**Re: DIR-2019-6352-CDP-MEL (SHP 1);  
DIR-2019-5524-CDP-MEL (SHP 2); ZA-2019-5525-ZAD;  
DIR-2019-5571-CDP-MEL (JDR 1); ZA-2019-5574-ZAD;  
DIR-2019-5584-CDP-MEL (JDR 2); ZA-2019-5585-ZAD;  
CEQA No.: ENV-2019-5520-MND**

Enclosed are our findings regarding the Environmental Impact Analysis of ENV-2019-5520-MND for the proposed development, specifically **I AESTHETICS, XI LAND USE AND PLANNING** and **XXI. MANDATORY FINDINGS OF SIGNIFICANCE**

SINGLE FAMILY  
HOME VISUAL  
COMPATIBILITY  
IN R-1 ZONE

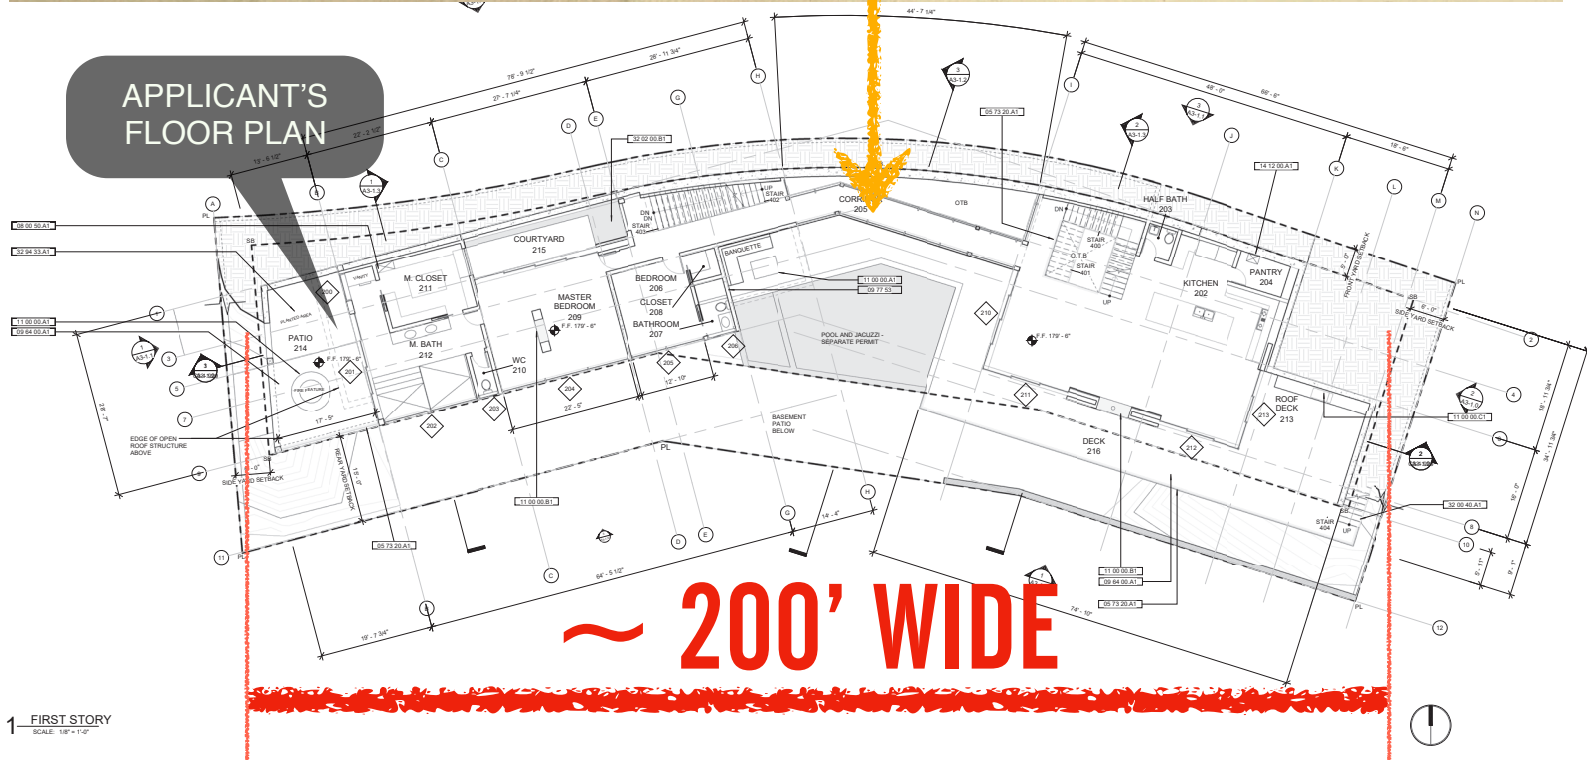
A SINGLE HOME OF THE PROPOSED DEVELOPMENT HAS  
3 TO 4 TIMES THE AVERAGE HOME WIDTH  
OF PRESENT HOMES ON THE BLUFFS  
~ 200'!

PROPOSED 17532 REVELLO HOME  
WIDTH OF OVER 200'!

EXTENDED SINGLE MASS OF NEW DEVELOPMENT  
OVER THE SCENIC VISTA OF THE CASTELLAMMARE  
BLUFFS DWARFS EXISTING HOMES
